Office Action Summary

10/645,965

CLINE, L. STEVEN

FIG. 1

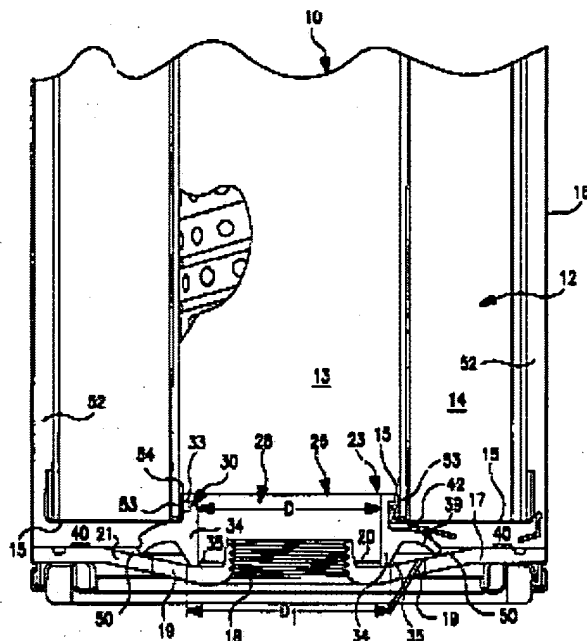
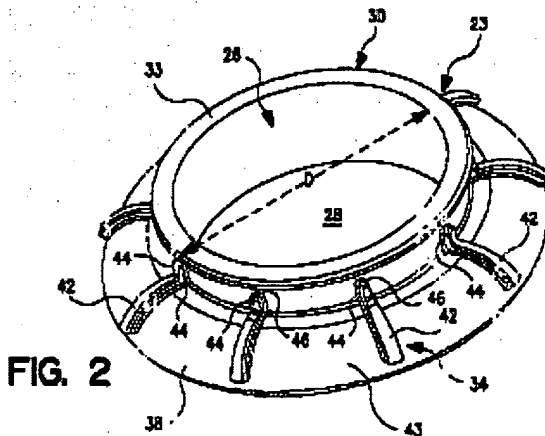
6. Claims 1-3, 5, and 8-14 are rejected under 35 U.S.C. 102(e) as being clearly anticipated by McKenzie (U.S. 6,793,808). McKenzie a fluid filter and valve assembly including a housing

having an end portion 17 including a threaded aperture and a central portion 53, 54 proximate thereto. An elastomeric valve assembly is positioned therebetween and includes an integral relief valve 30 and anti-drain back valve 34. See the drawings and the whole description thereof.

FIGURE 7

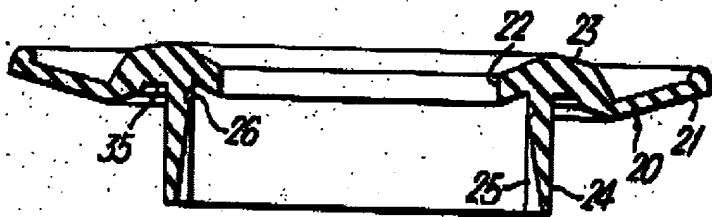
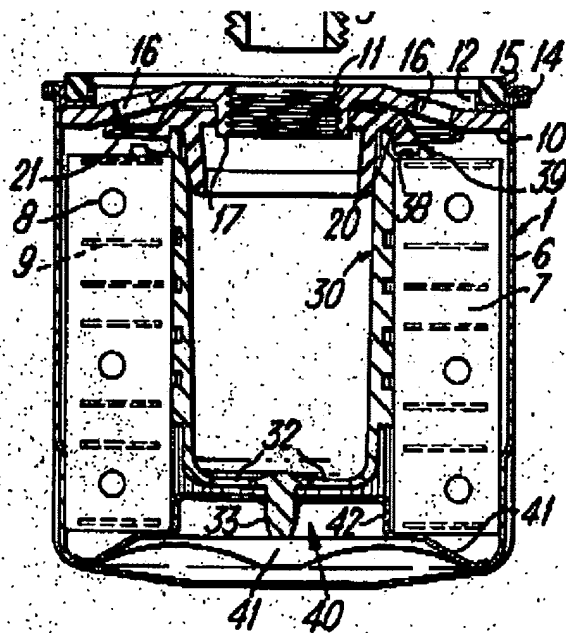
7. Claims 1-3 and 5-16 are rejected under 35 U.S.C. 102(b) as being clearly anticipated by Buckman (U.S. 3,567,023). Buckman teaches a fluid filter and valve assembly including a having an end portion 10 including a threaded aperture 11 and inlets 16 and a central portion 30 proximate thereto. An elastomeric valve assembly (figure 7) is positioned therebetween and includes an integral relief valve 24 and anti-drain back valve 20. The U-shaped recess 35 is also taught. See the drawings and the whole description thereof.

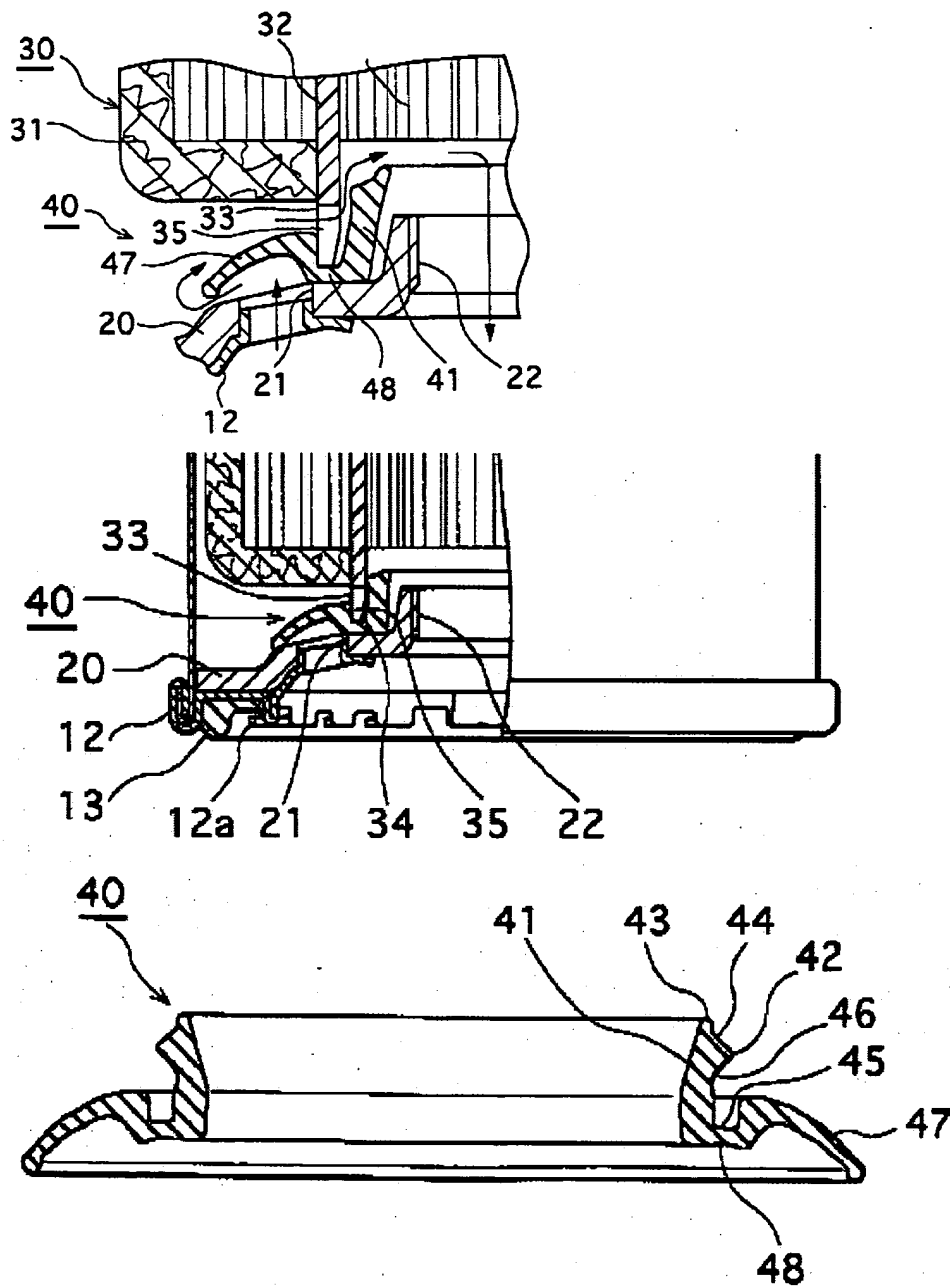
8. Claims 1-17 are rejected under 35 U.S.C. 102(b) as being clearly anticipated by Suzuki et al. (U.S. 6,136,183).
